BOYKIN PLANTATION SUBDIVISION

APPLICATION NUMBER 23 DATE October 4, 2012
 APPLICANT Boykin Plantation Subdivision
 REQUEST Subdivision

DETAIL SITE PLAN

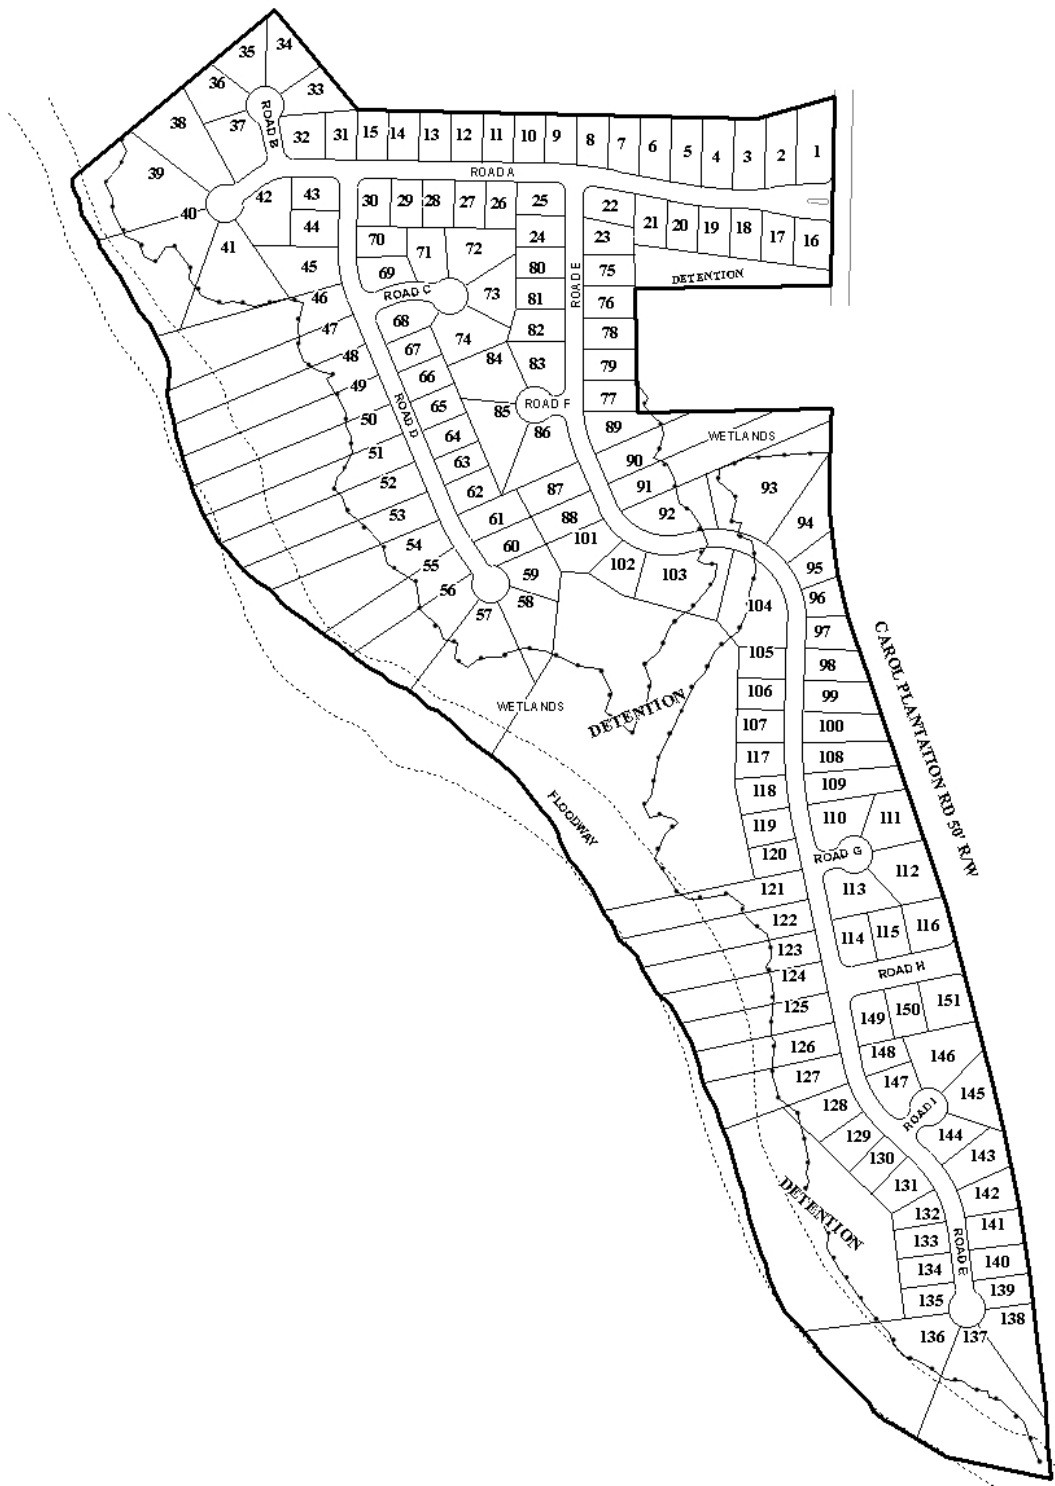
The site will be composed of streets connecting multiple cul-de-sacs. The proposed Road “D” cul-de-sac street appears to exceed the Section V.B.6. recommended 600-foot maximum length, in that it will be approximately 840 feet long. All other cul-de-sacs are less than the maximum length.

All of the proposed cul-de-sacs appear to be drawn with a diameter of approximately 98 feet, which is less than the 120 foot diameter required by Section V.B.14. of the Subdivision

Regulations. The plat should be revised to depict the correct required minimum diameter, and lot sizes revised as necessary.

The 25-foot setback line and notation is not depicted on the preliminary plat. The plat should be revised to depict and note the 25-foot minimum building setback line as required by Section V.D.9. of the Subdivision Regulations, and should also be depicted from both street frontages for those lots with double-frontage.

No phases are depicted on the plat. If the subdivision will be developed in phases, those phases should be depicted on the plat.

Common areas are proposed for the site. All common areas should be labeled, and notes should be placed on the preliminary plat stating that maintenance shall be the responsibility of the property owners.

Wetlands and floodplains exist on the site, in association with Rabbit Creek. The plat depicts the floodway and delineated wetlands, but does not depict the AE or X-shaded zones. The plat should be revised to depict all necessary flood zones, and any finished floor elevations that may be required by Mobile County Engineering. A note should also be placed on the plat stating that development of the site must be undertaken in compliance with all local, state and federal laws as they relate to wetlands and floodplains.

It appears that the proposed subdivision does not include the entirety of parcel R023308332000001. The plat should be revised to include the entire parcel.

Finally, the plat should be printed at a standard engineering scale, rather than the 1 inch = 140 feet scale as submitted.

- 1) Revision of the plat to include the entirety of parcel R023308332000001.;
- 2) Revision of the plat to reduce the maximum cul-de-sac length of Road "D" to comply with Section V.B.6. of the Subdivision Regulations;

- 3) Revision of the plat to depict the correct diameter of the cul-de-sac right-of-way for all cul-de-sacs, to be 120-feet, in compliance with Section V.B.14. of the Subdivision Regulations;

- 4) Revision of the plat to depict the 25-foot minimum building setback line from all streets, including Carol Plantation Road, as required by Section V.D.9. of the Subdivision Regulations;

- 5) Revision of the plat to depict phases, if the subdivision will be developed in phases;
- 6) Revision of the plat to depict all typically required flood zones (AE and X-shaded), as well as Mobile County Engineering requirements for finished floor elevations;

- 10) Revision of the plat to label all common areas, and to include a note stating that maintenance of common areas shall be the responsibility of the property owners;

- 12) Submission of the revised plat printed at a standard engineering scale.
